**JOINT REGIONAL PLANNING PANEL
(East Region)**

JRPP No	2016SYE069
DA Number	DA14/080/02
Local Government Area	Bayside Council
Proposed Development	<p>Section 96(2) application to modify Development Consent No. 14/080 approved by the Joint Regional Planning Panel for the remediation of the site, removal of existing vegetation and construction of 35 x two and three storey townhouses and two residential flat buildings, above ground parking for 465 vehicles, and associated landscaping and public domain works. This Section 96(2) application now seeks to:</p> <ul style="list-style-type: none"> • Delete Level 7 in accordance with the conditions of consent; • Amend the unit layout to reduce the number of apartments from 221 to 219; • Increase diversity of unit size and mix with an introduction of four bedroom units and a decrease in studio/1 bedroom apartments; • Increase the height of the ground floor car park from 2.7m to 3.1m for service vehicle access; • Increase the height of the central portion of the buildings to provide additional areas at the rooftop levels for communal lounge and open space; • Provide two additional townhouses resulting in a total of 37 townhouses; • Increase t

Figure 11 – Section View looking south from Holloway Street

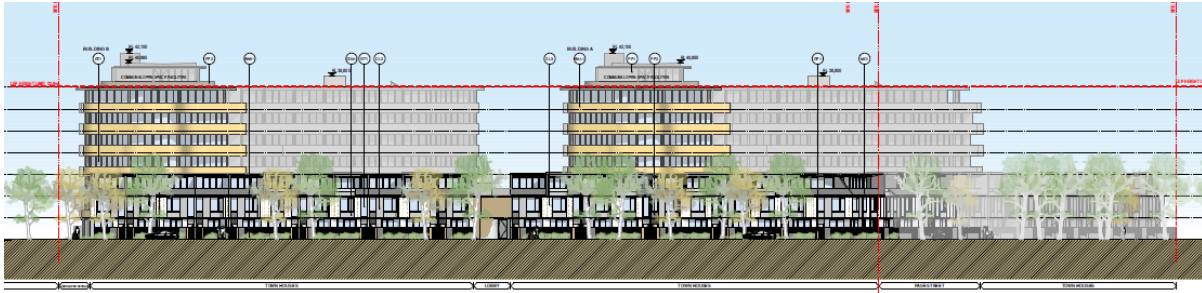
- It is proposed to introduce a communal rooftop lounge and terrace to both Building A and B, to create an overall building height of RL42.1m, being

26.8m above existing ground level, which is an overall height exceedence of 4.8m.

Figure 12 - Section View looking south

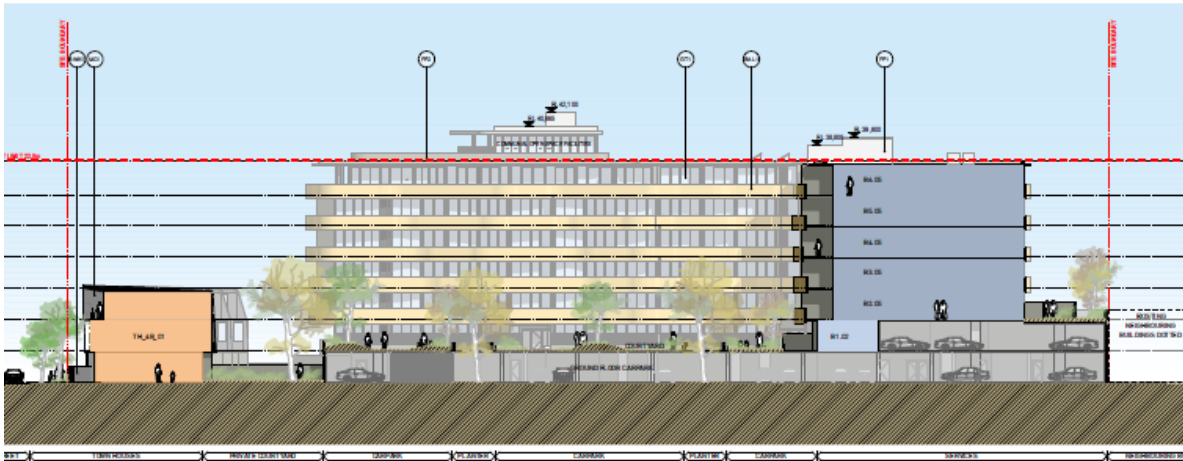
The applicant now seeks to increase the height to 42.1 metres AHD (26.8m), a variation of 4.8 metres for the lift overrun. Specifically, the variations are:

The modified height is a maximum of 26.5m. The additional height being between 1.5m and 4.8m above the height control) is a result of:

- *Lift overruns which exceed the control by approximately 1.5m, which is considered consistent with the approved DA.*

- *The rooftop lounge which is approximately 3.4m above the height control, with a lift overrun approximately 4.8m above the control.*

The applicants arguments are not agreed with. The assertion that the original DA approved a lift overrun of 1.5m is not correct, as the Panel approved the original DA with a condition that the maximum height of the building must not exceed 22m. The definition of height includes lift overruns, therefore the applicant was required to explore alternative measures to ensure there was no breach of the height control.

The additional height sought by this modification will result in a significant variation to the control, purely for the communal lounge room, communal terrace and lift overruns of differing heights (including one up to 4.8m), being 1 metre over that originally proposed under the original DA. Each communal room is 80.61m². Overall the proposed GFA to Level 7 is within the existing approved GFA, as there is a re-distribution of the GFA through a complete redesign of each floorplate. However, despite the GFA and FSR remaining compliant, the extent of the height variation at its greatest is 4.8m or 22%. The extent of this variation is not supported as there are no sound reasons for the variation. The concept of communal spaces both internally and externally is supported, however the proposed location on Level 7, beyond the height limit is not accepted, as there is no reason why these spaces cannot be

provided at a level below which would bring the height into compliance which can still be lowered through the use of lifts which do not have overruns.

Therefore it is recommended that an apartment on Level 6 of each of Building A and B is converted to a communal lounge and terrace in lieu of that now proposed on Level 7. The introduction of the communal area to the roof top of Building A and B will create an undesirable precedent for variations to height controls and were there are no sound reasons to do so. In this instance, there is no reason why the communal area cannot be provided at Level 6 and alternative lift overruns be explored.
